Watts Bar Nuclear Plant, Unit 2
NRC Docket No. 50-391

Subject: Watts Bar Nuclear Plant (WBN) Unit 2 – Response to Request for Additional Information (RAI) Regarding June 28, 2011 NRC Audit – Steam Line Break (SLB) and other Miscellaneous RAIs

Watts Bar Unit 2 Completion Program – Responses to Additional NRC Non-LOCA RAIs

Enclosure 3
TVA Letter Dated July 29, 2011
FSAR mark-ups for SLB transients

Figure 15.4-11b Transient Response to Steam Line Break with Safety Injection and Offsite Power (CASE A)

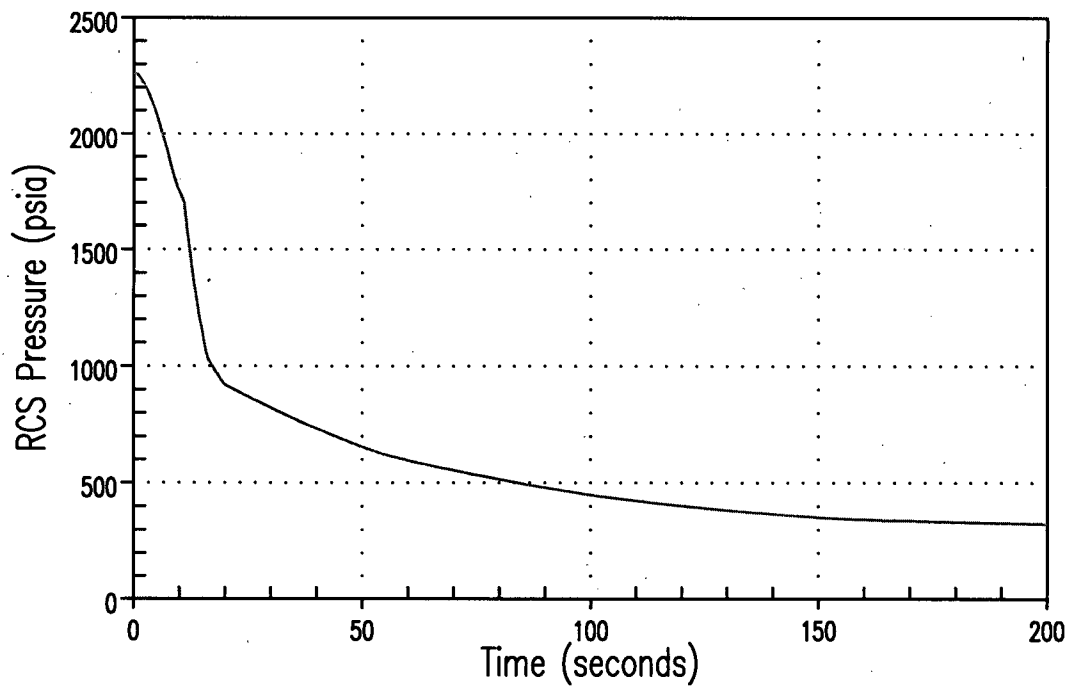
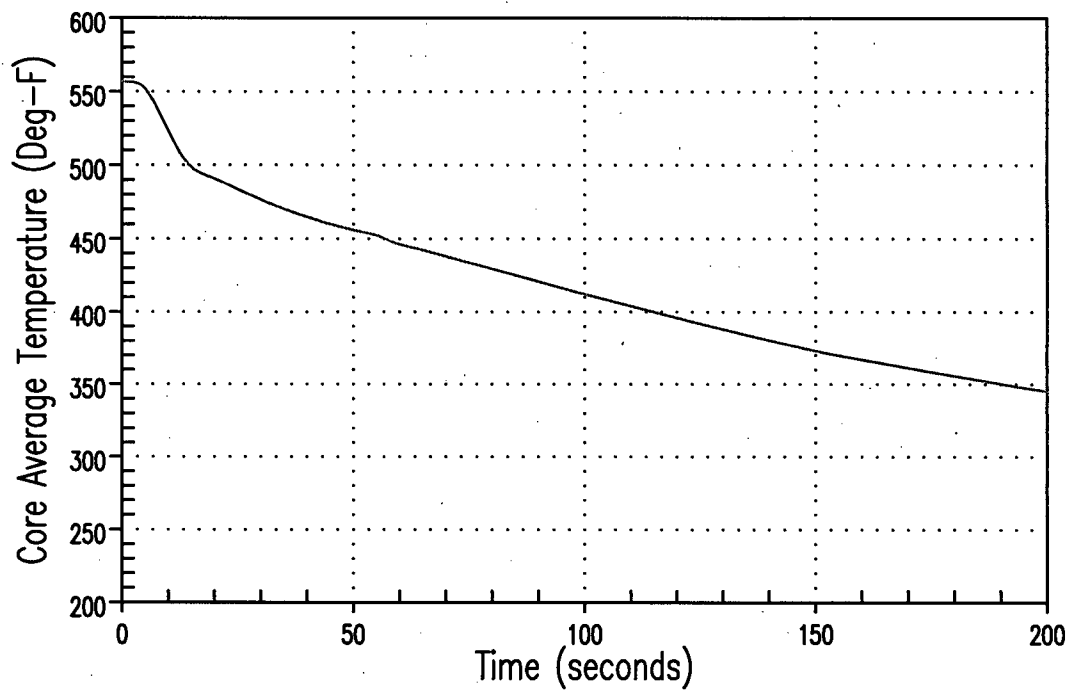
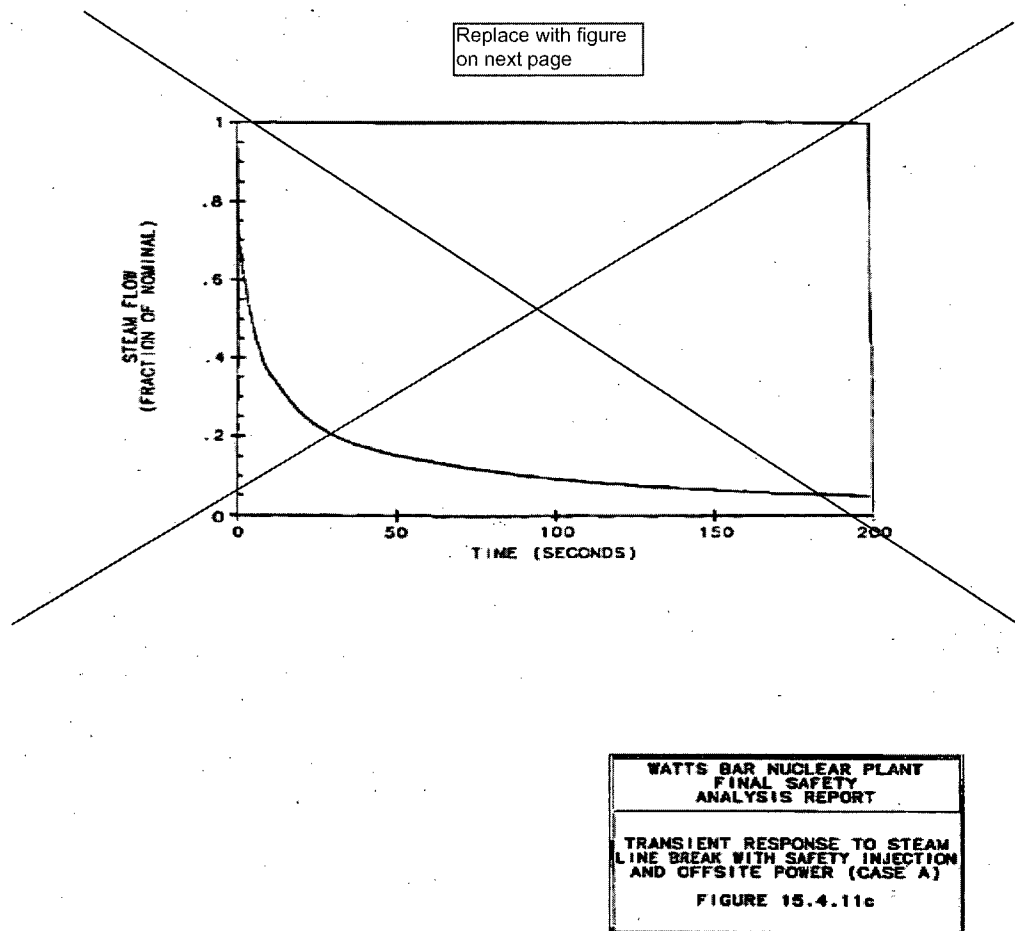
It should be noted that the safety injection accumulators are actuated in Case (a) due to low RCS pressure (Figure 15.4-11b). Once the accumulators actuate, 2400 ppm boron is delivered to the core and the transient is terminated before a significant return to power is achieved. Once the transient is terminated and the plant is stabilized, emergency operating procedures may be followed to recover from the MSLB event.

Figure 15.4-12a Transient Response to Steam Line Break without Offsite Power
Nuclear Power and Reactivity Versus Time

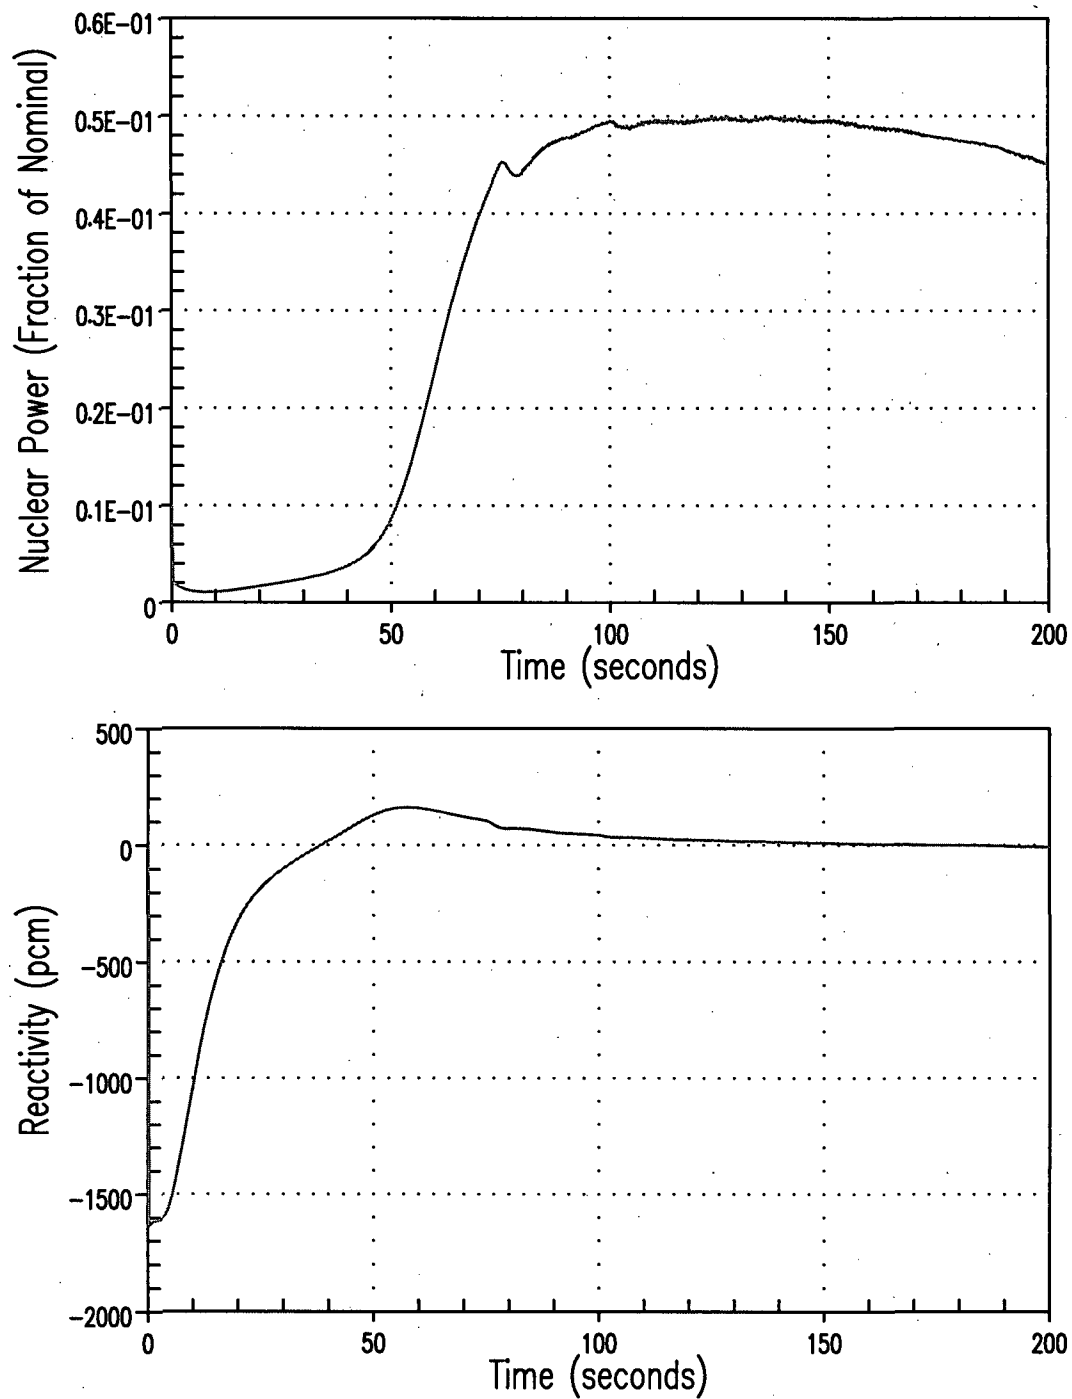
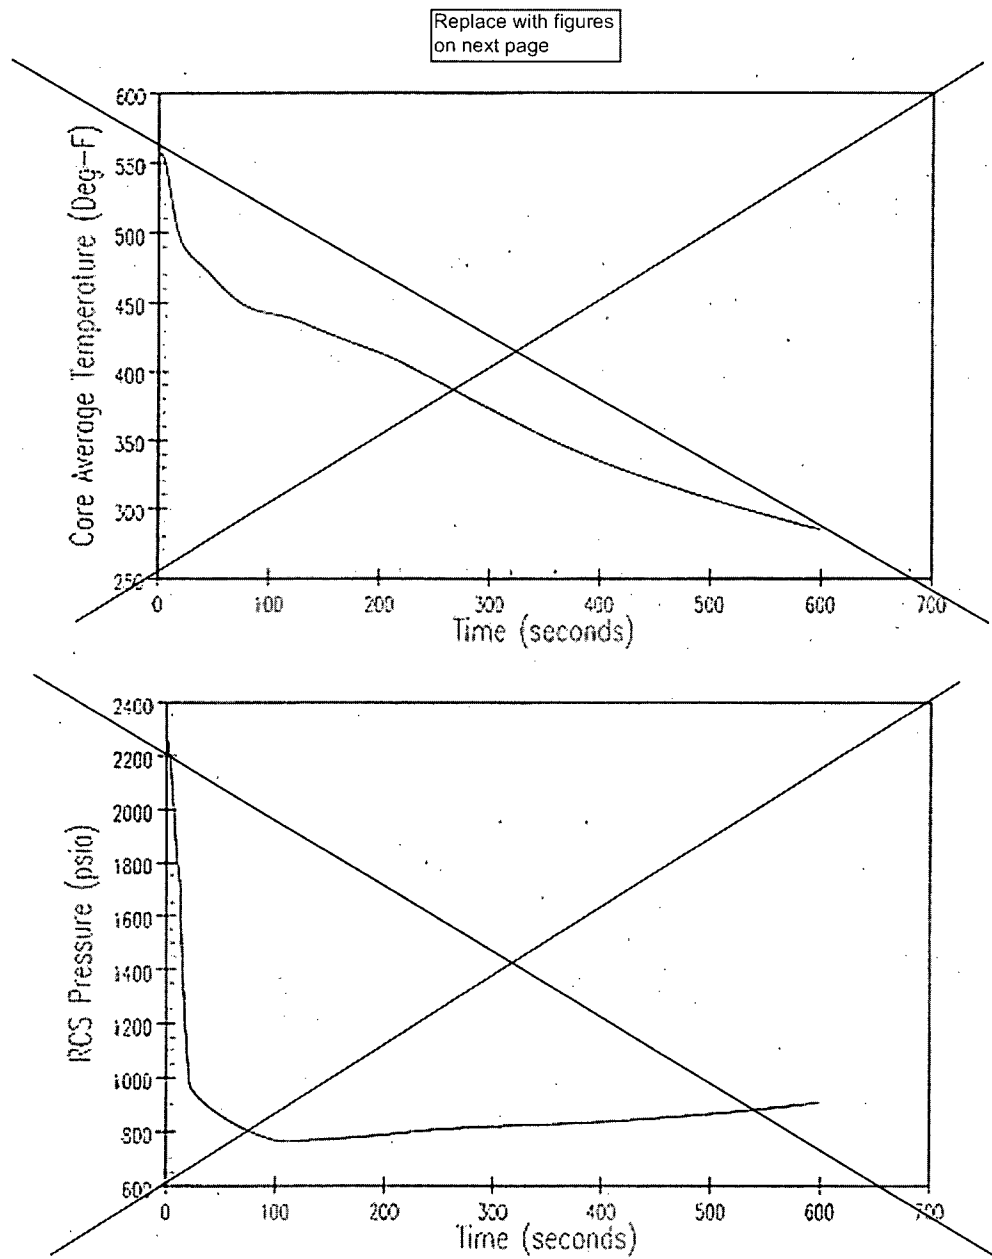
Figures 15.4-12a through 15.4-12c show the responses of the salient parameters for Case b which corresponds to the case discussed above with additional loss of offsite power at the time the safety injection signal is generated. The injection of borated water is conservatively delayed to 37 seconds based on the assumed 10 second diesel generator delay time plus the 27 seconds associated with the valve lineup for the offsite power available case (Case a). In this case criticality is achieved later and the core power increase is slower than in the similar case with offsite power available. The ability of the emptying steam generator to extract heat from the reactor coolant system is reduced by the decreased flow in the reactor coolant system. For both these cases the peak power remains well below the nominal full power value.
